UNITED STATES PATENT AND TRADEMARK OFFICE

APPLICATION NO.	FILING DATE	FIRST NAMED INVENTOR	ATTORNEY DOCKET NO.	CONFIRMATION NO.
10/786,424	02/25/2004	Kenneth S. Collins	306 D13	2804

Office Action Summary

DETAILED ACTION

Fig. 2

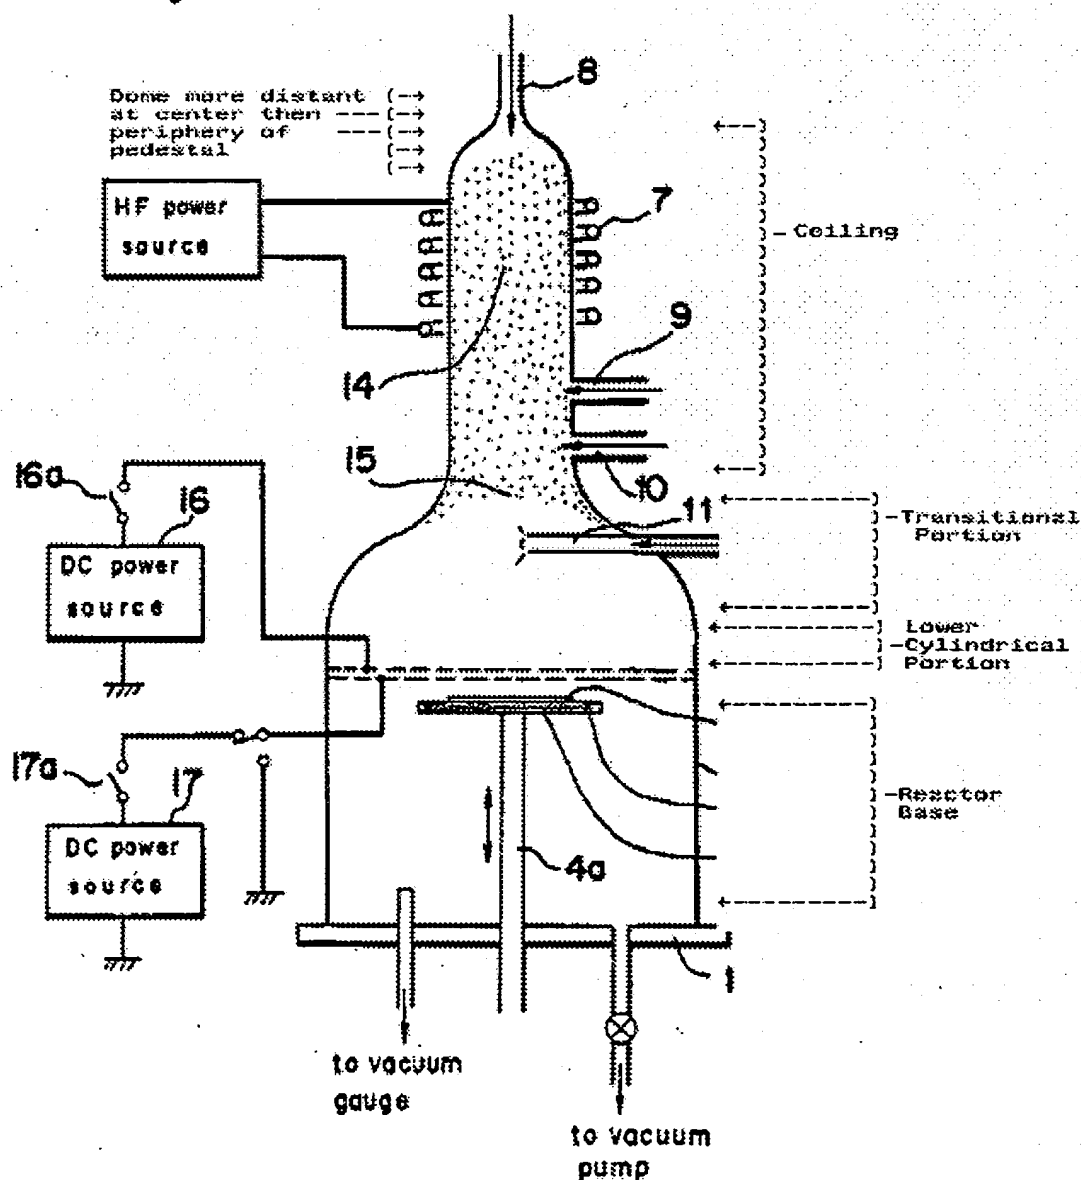
Regarding Claims 1, 2, 10, 11, 22, 23, 25 and 26, Hotomi teach in Fig. 2 a plasma chamber. (See Fig. 2) The plasma chamber includes a pedestal 4, which is adapted to hold a workpiece 3 to be processed. (Column 9 lines 65-68) A reactor base including base plate 1 houses the pedestal. (Column 9 lines 60-61; the reactor base includes the area between the grid and the base plate 1.) A high-frequency coil 7 is arranged adjacent the reactor and inductively couples power into the reactor. (Column 10 lines 11-17) The plasma chamber enclosure structure includes a bell jar 2. (Column 10 lines 60-64) The bell jar 2 is single walled. (See Fig. 2) The enclosure structure is inverted cup shape in

configuration. (See Fig. 2) The plasma chamber structure includes a ceiling. (See Figure 2) The plasma chamber enclosure has a central gas inlet 8. (Column 10 lines 18-19) The plasma structure has a sidewall. (Fig. 2) The plasma enclosure has a lower cylindrical portion generally transverse to the pedestal. (Fig. 2) There is a transitional portion between the lower cylindrical portion and the ceiling. The transitional portion extends inwardly from the lower cylindrical portion and comprises a radius of curvature. (See Fig. 2) See Annotated Figure below.

The plasma chamber enclosure structure covers the base. (See Figure 2) A plasma processing volume is 14, 15 defines a plasma-processing volume over the pedestal. (Column 11 lines 68; Column 12 lines 1-5) The plasma chamber enclosure is capable of transmitting inductive power through the enclosure from an antenna. (Column 10 lines 12-17)

The differences between Hotomi and the present claims are that the flattened conical configuration of the ceiling is not discussed, the plasma chamber enclosure structure being formed of a dielectric material of silicon, silicon carbide, quartz or alumina is not discussed and the flange portion extending radially outward from the side wall.
